UNITED STATES PATENT AND TRADEMARK OFFICE

Office Action Summary	Application No. 10/613,494	Applicant(s) LEE, JUN-YOUNG	
	Examiner Seokyun Moon	Art Unit 2629

DETAILED ACTION

Drawing 1

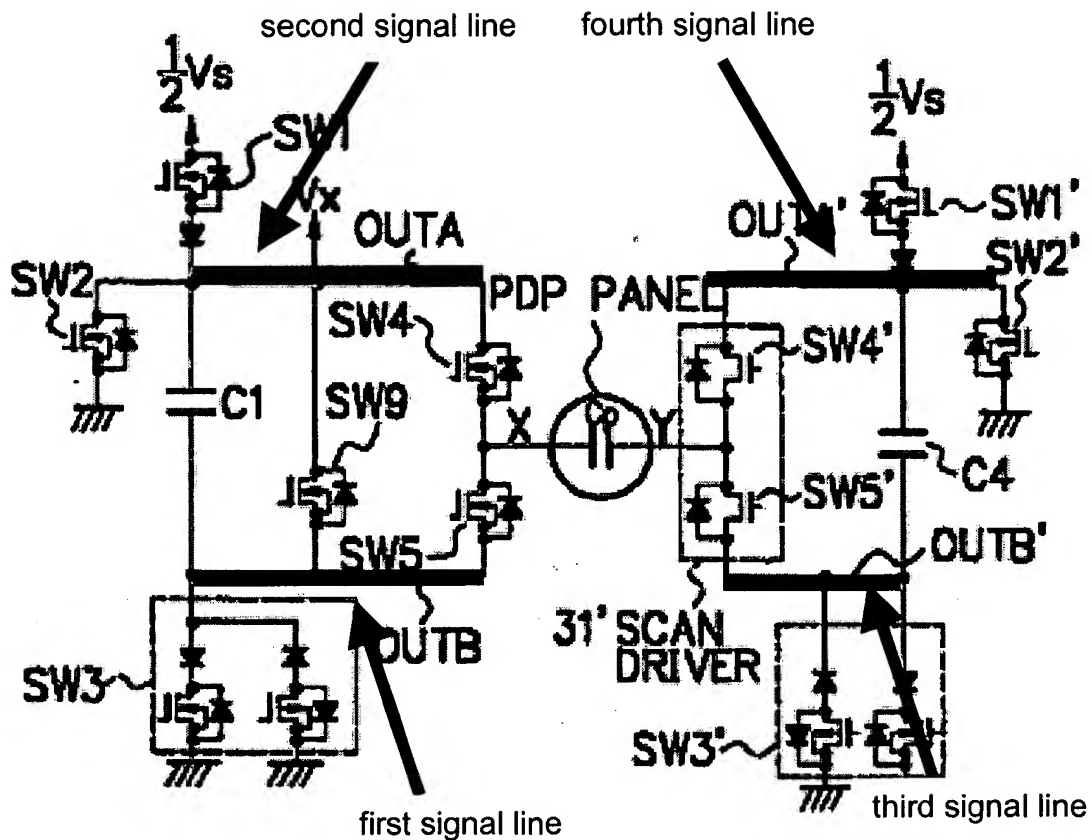
a first signal line coupled to a common contact between the first switch and the second switch [drawing 1 provided below, which is equivalent to Kishi's fig. 62]; and

wherein a voltage between the first signal line and the second signal line is a third voltage ("1/2Vs"), the first voltage and the second voltage are alternatively applied to the first terminal of the panel capacitor, and

wherein a ground voltage is applied to the first signal line while the second voltage ("1/2Vs") is applied to the first terminal of the panel capacitor.

a third signal line coupled to a common contact between the fifth switch and the sixth switch [drawing 1 provided on page 5 of this office action]; and

As to **claim 15**, Kishi [fig. 62] [drawing 1 provided on page 5 of this office action] teaches a method for driving a plasma display panel, by alternatively applying a first voltage (" $1/2V_s$ ") and a second voltage ("*ground*") respectively through a first signal line and a second signal line both coupled to a first terminal ("*X*") of a panel capacitor ("*C_o*"), a first common contact being formed between a first switch and a second switch located between a third switch and a fourth switch located on the second signal line, the method comprising:
